Request for Additional Information No. 297 (3759, 3719, 3775), Supplement 1, Revision 0

U. S. EPR Standard Design Certification
AREVA NP Inc.
Docket No. 52-020
SRP Section: 06.02.01 - Containment Functional Design
SRP Section: 06.02.02 - Containment Heat Removal Systems
Application Section: FSAR Chapter 6

Question 06.02.01-52:

Figure 06.02.01-52-1—Containment Pressure for the Sequence of Benchmark Cases using the Multi-Node GOTHIC Model – ICECON Prediction

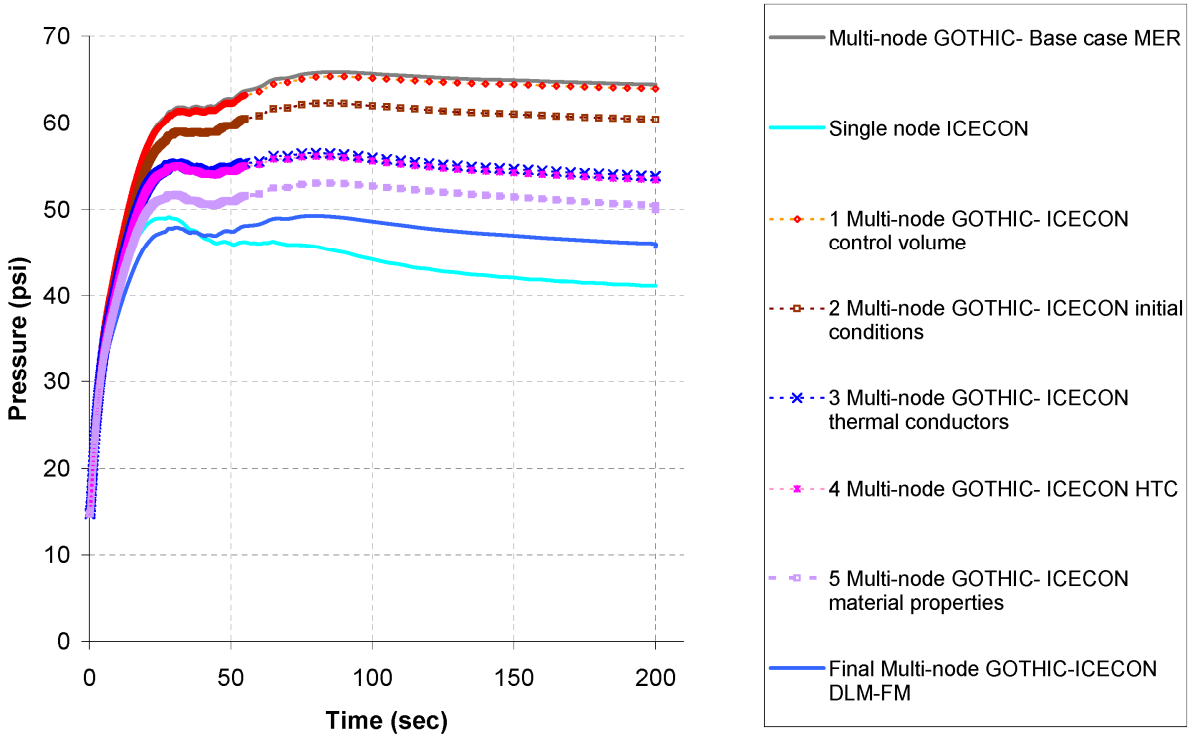
In an SER concerning reload of AREVA fuel into the North Anna Power Station (ML040370390), the staff concluded that AREVA methodology for calculating minimum containment back pressure using the ICECON code could be accepted if it is shown to be conservative for each case. For US-EPR provide a benchmark showing that, for the limiting large break LOCA analyzed of FSAR Chapter 15, the ICECON methodology is conservative compared with a best estimate analysis using the AREVA multi-node GOTHIC model. The same mass and energy releases should be input into both ICECON and GOTHIC.

The pressure responses for the various multi-node GOTHIC benchmark cases are compared with the ICECON response in Figure 06.02.01-52-1. The gradual decrease of containment pressure, as a result of the successive additive changes made, is shown in Figure 06.02.01-52-1.
